ARTESIA PUMP STATION ADDITIONAL WELL NOS. 7 AND 8

Solicitation No: CO-00416

ADDENDUM 3

Date: SEPTEMBER 15, 2021

SHEET E-10
35 OF 41

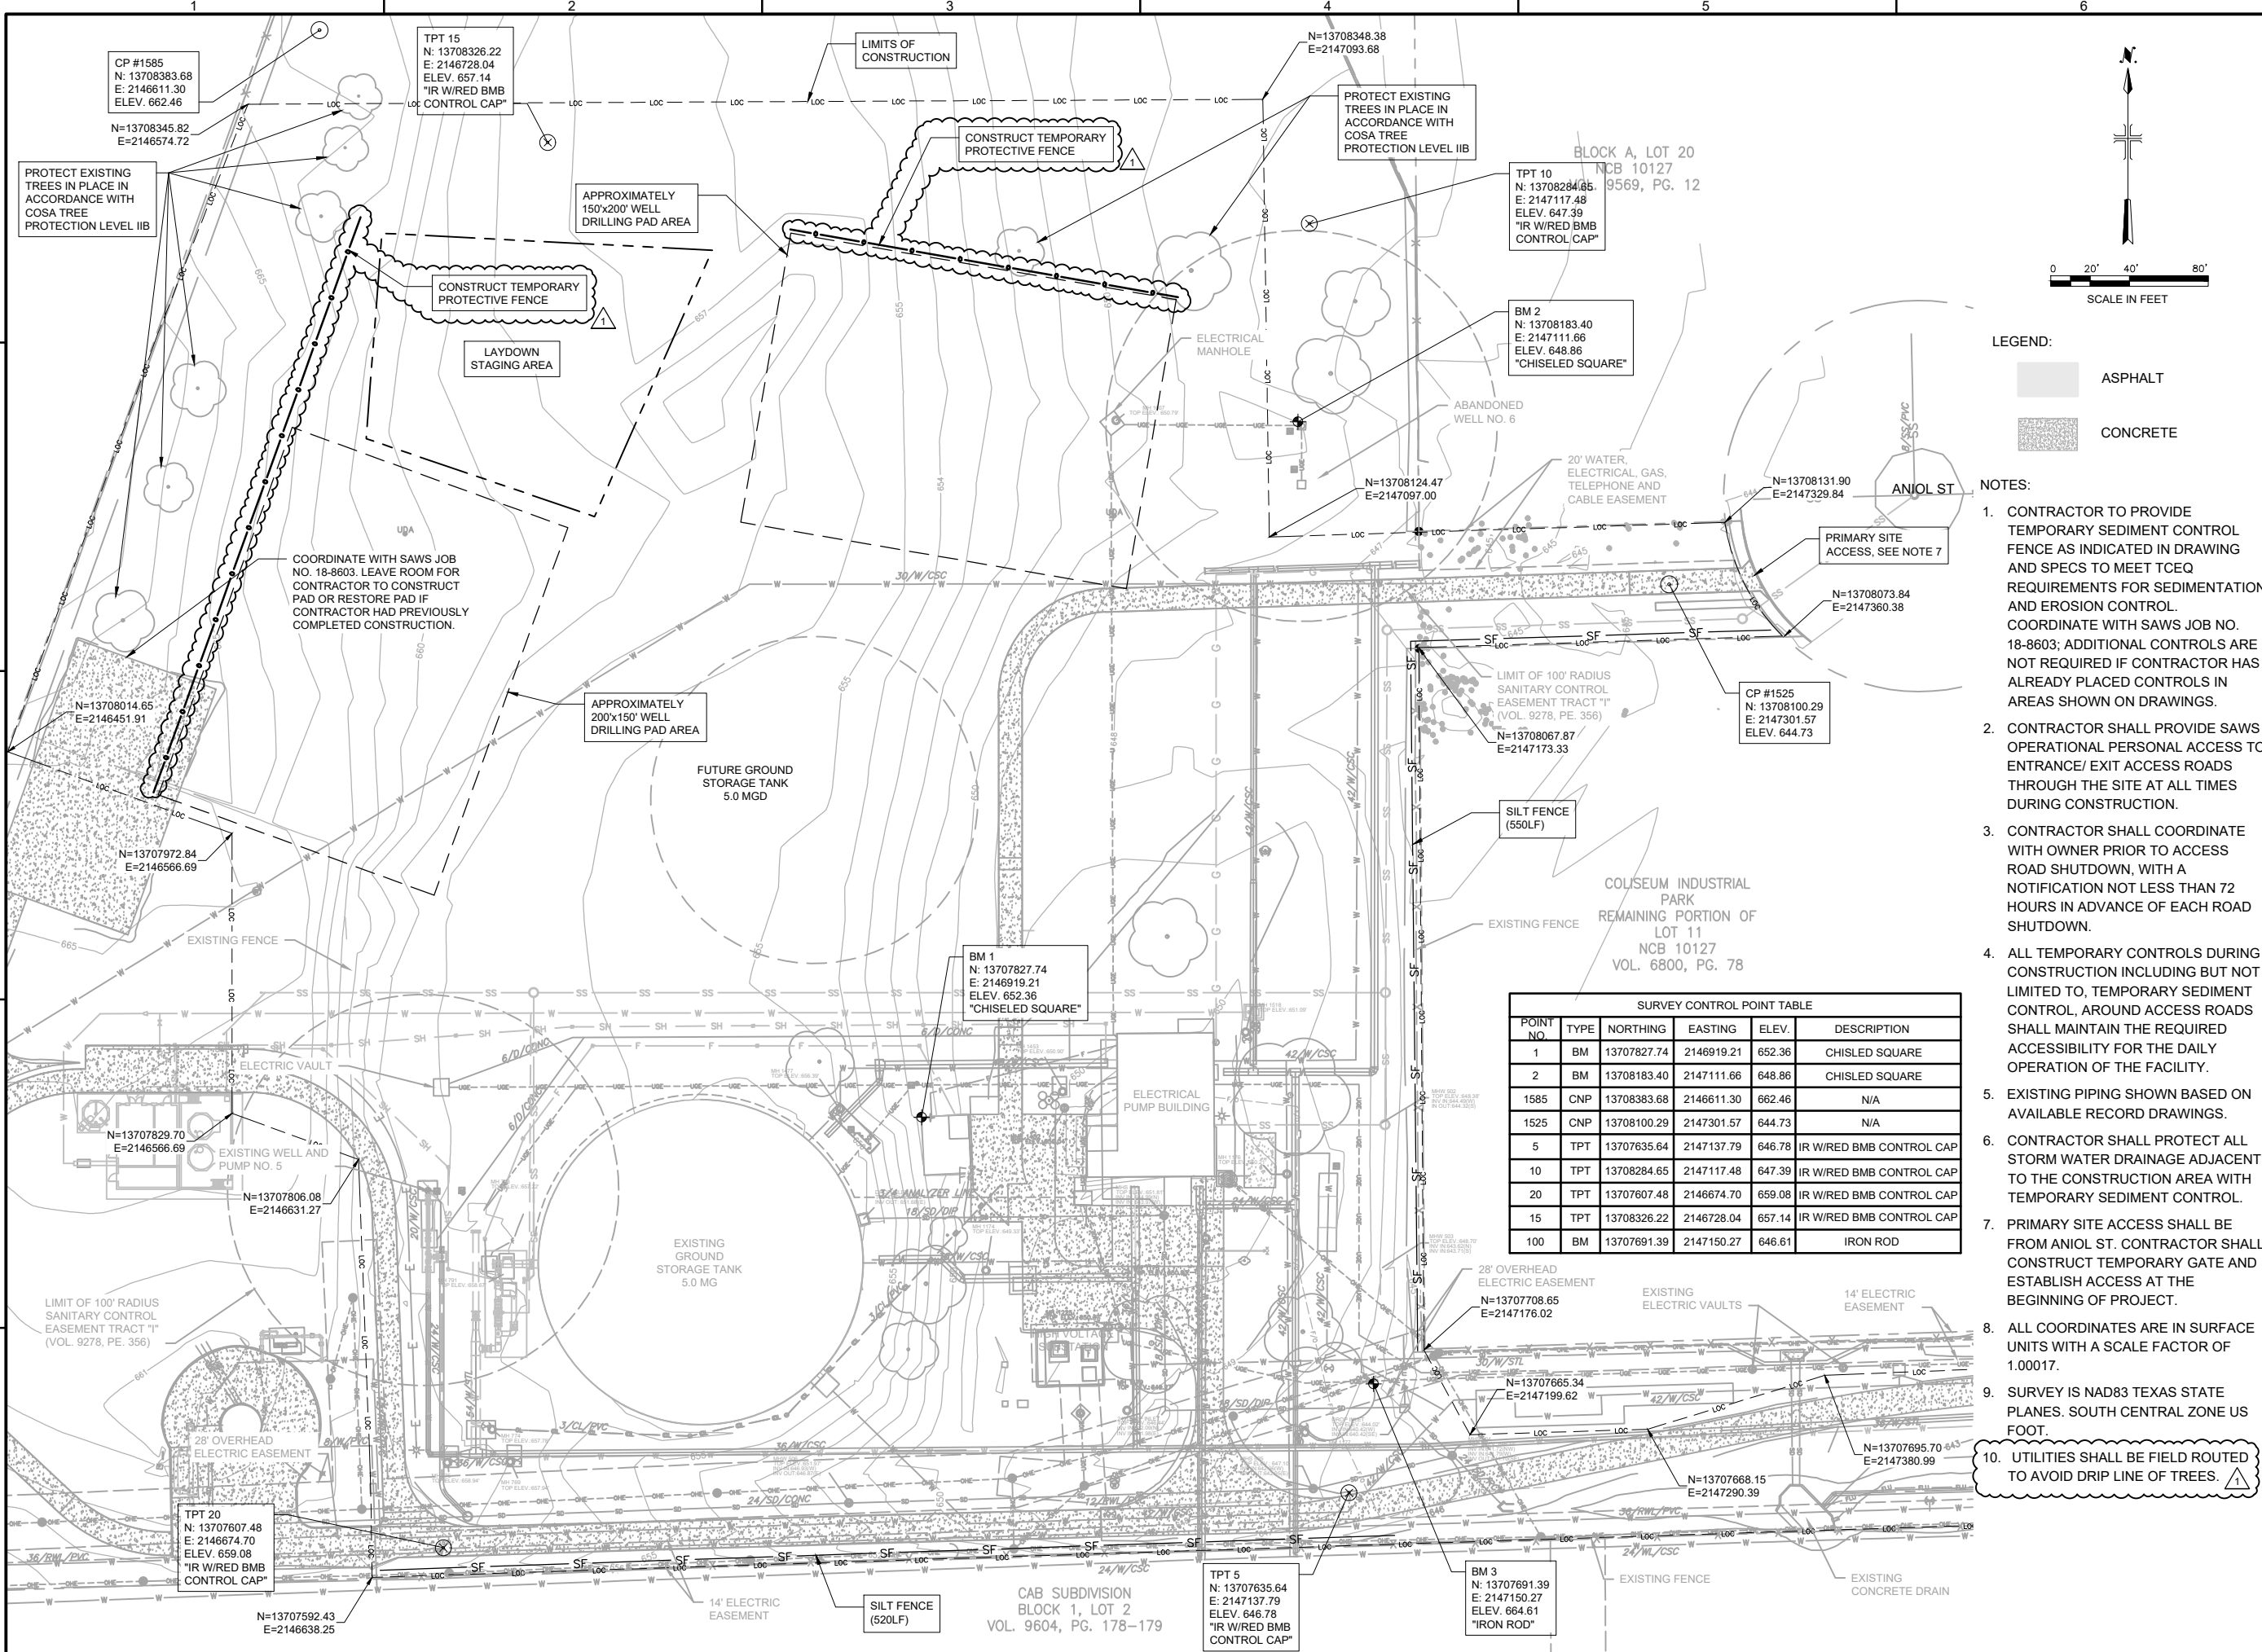
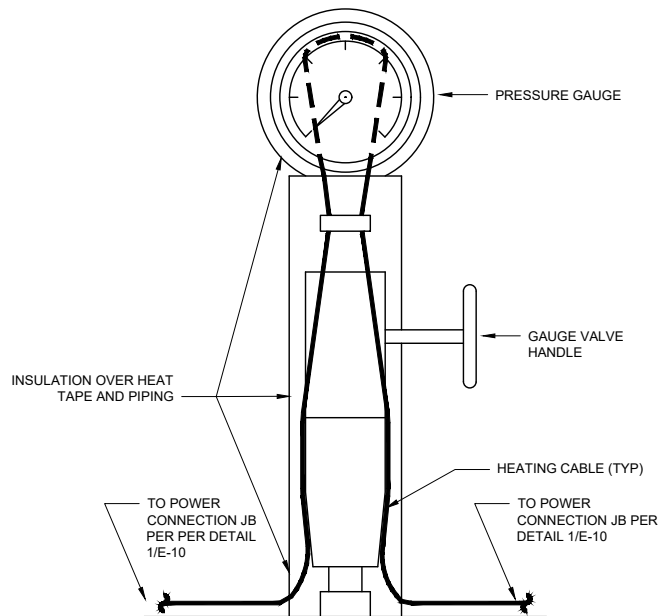
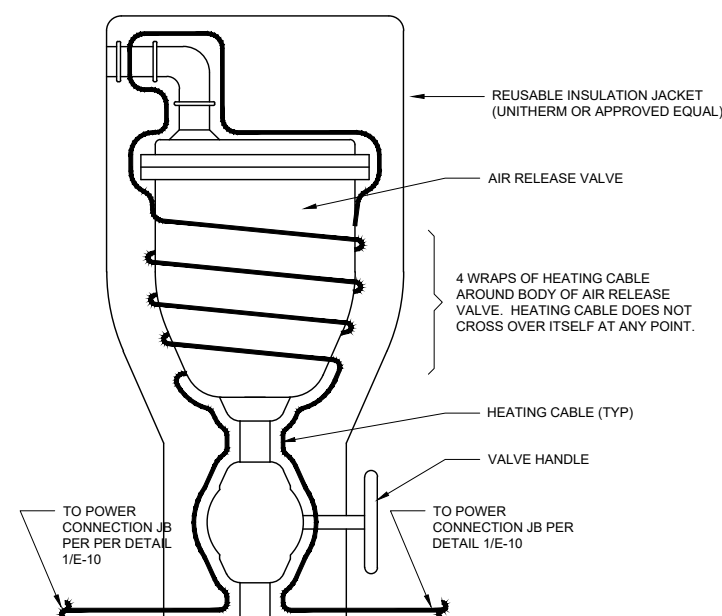
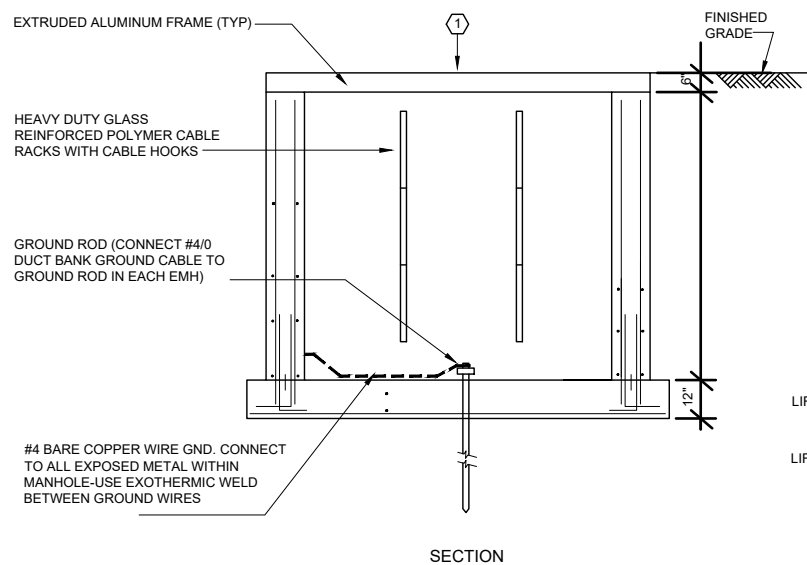
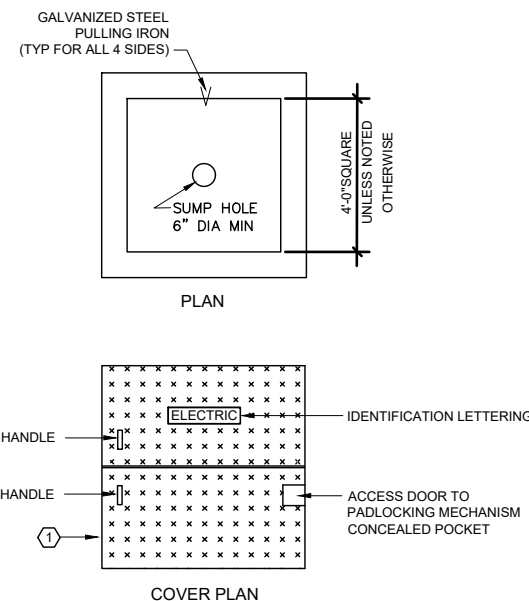
1. **Delete** Drawing E-10 and **replace** with revised Drawing E-10, attached. This change is for a permitting requirement only and is a clarification for City of San Antonio.

SHEET TITLE
MECHANICAL
WELL NO. 7 & 8 SECTION
SCALE: AS SHOWN
SHEET **M-03**
16 OF 41

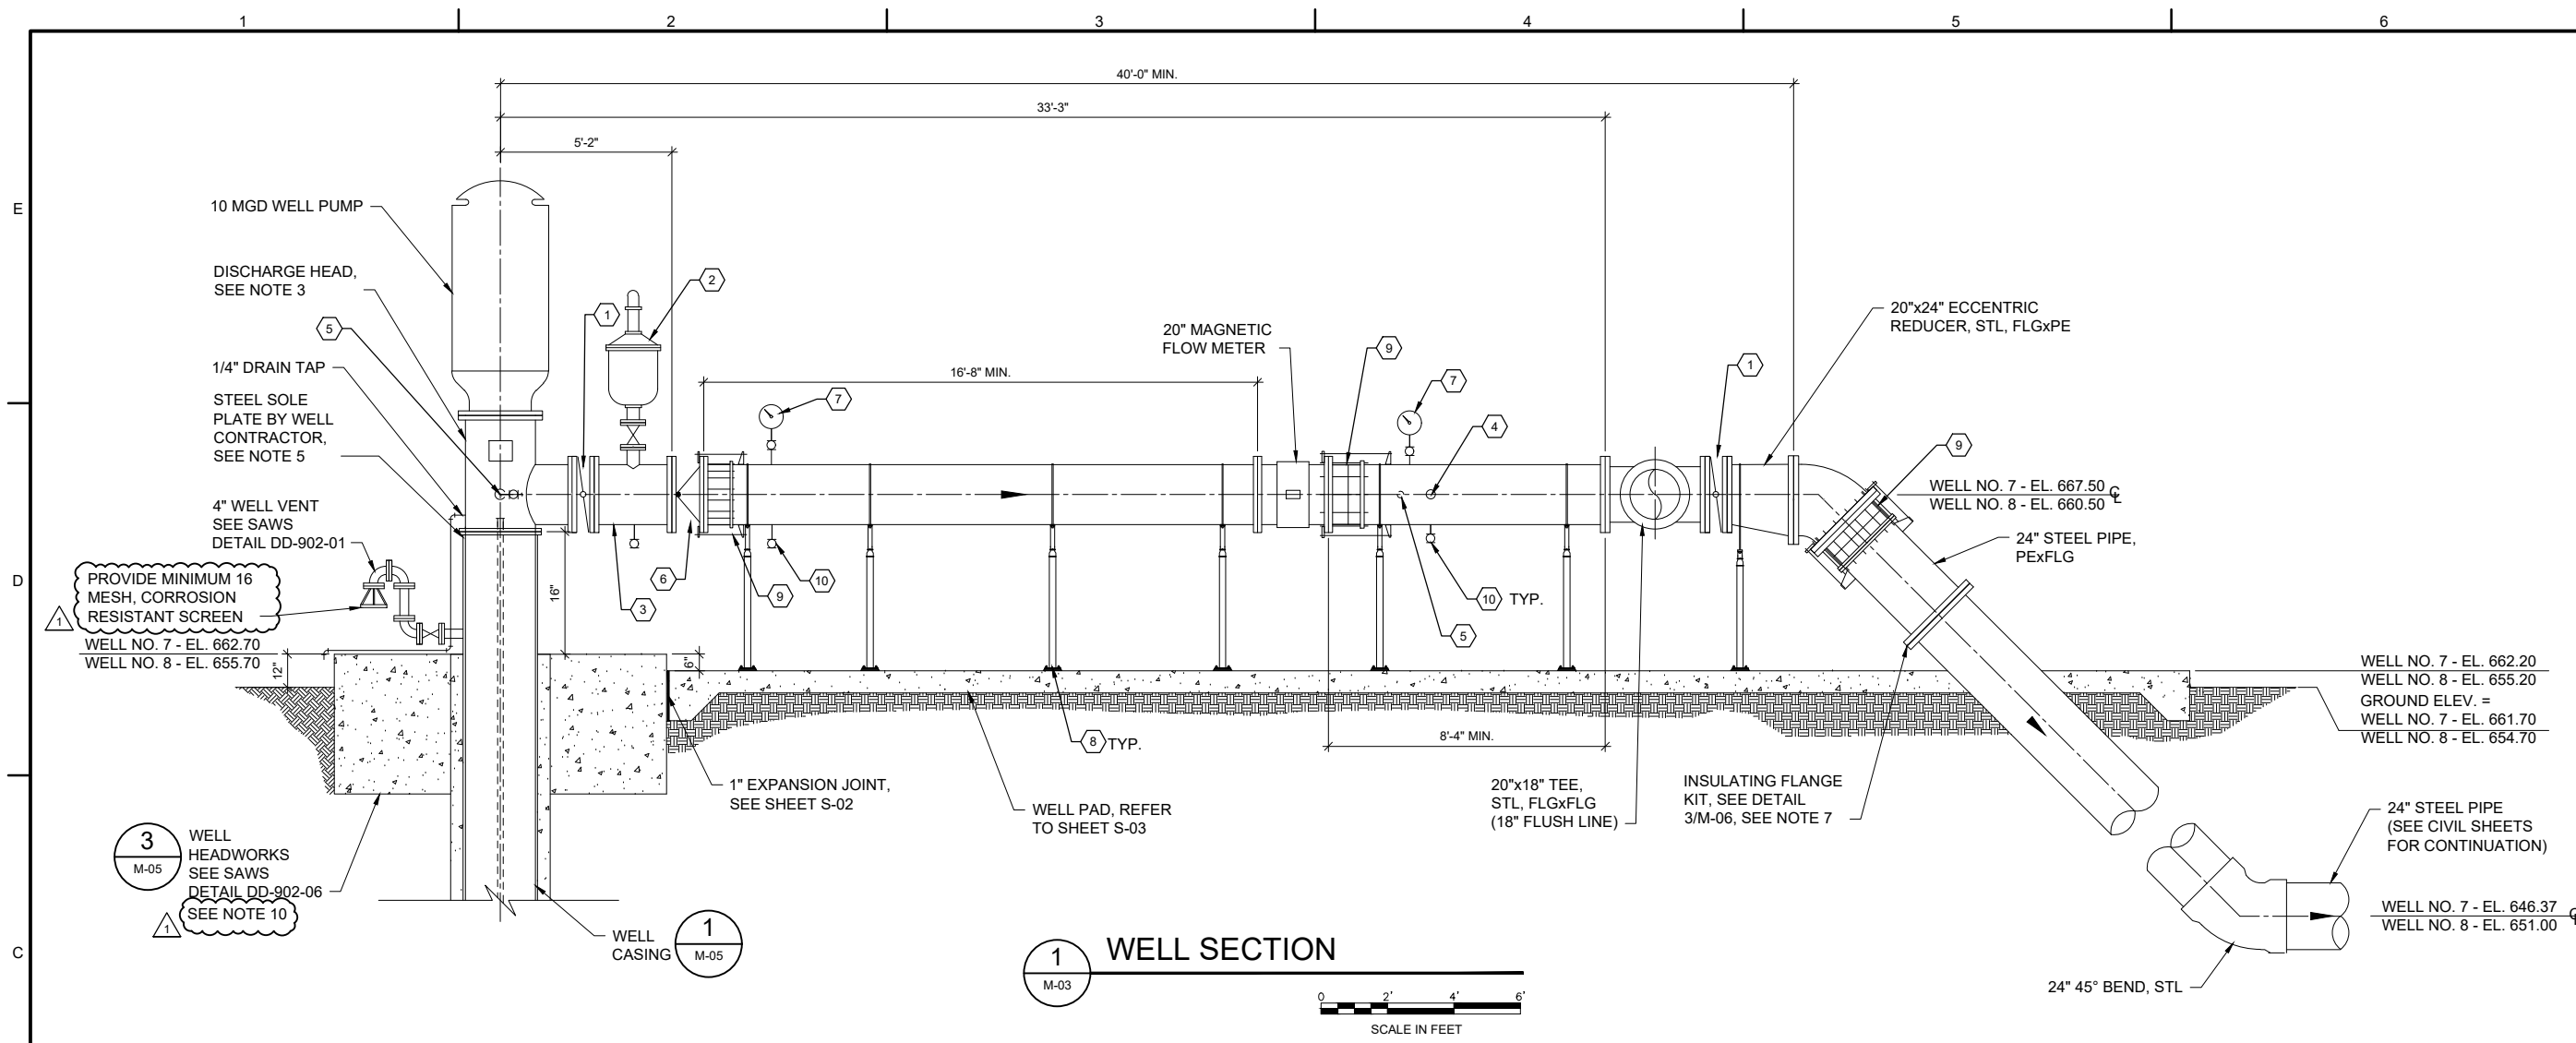
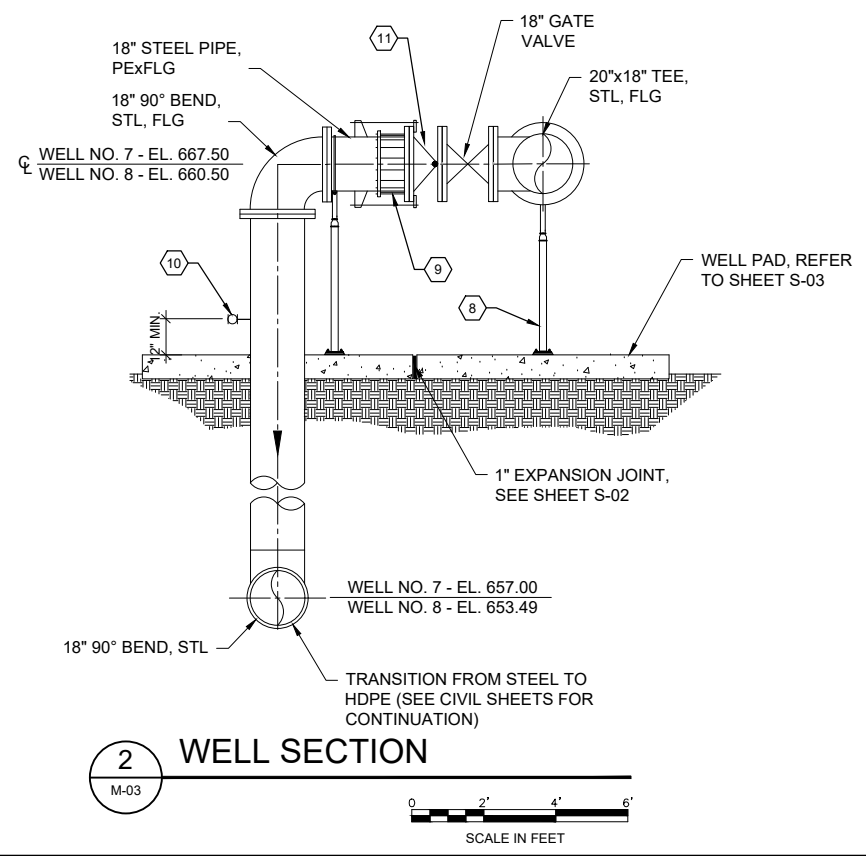
- 8. Question: Plan Drawing M-03 – Add anchored pipe support under 20” butterfly valve. Discharge flange should not be supporting weigh of valve.**
Response: Not all pipe support locations are shown on plans. Piping shall be supported as needed. Contractor’s shop drawing submittal shall show the locations of pipe supports, and calculations for pipe support shall be provided for review by Engineer in accordance with the Specifications.

3. **Delete** Drawing M-03 and **replace** with revised Drawing M-03, attached. This change is for a permitting requirement with TCEQ and includes clarification regarding monolithic pour of well headworks and including 16-mesh screen on well vent header.

10. WELL HEADWORKS SHALL BE MONOLITHIC. 1
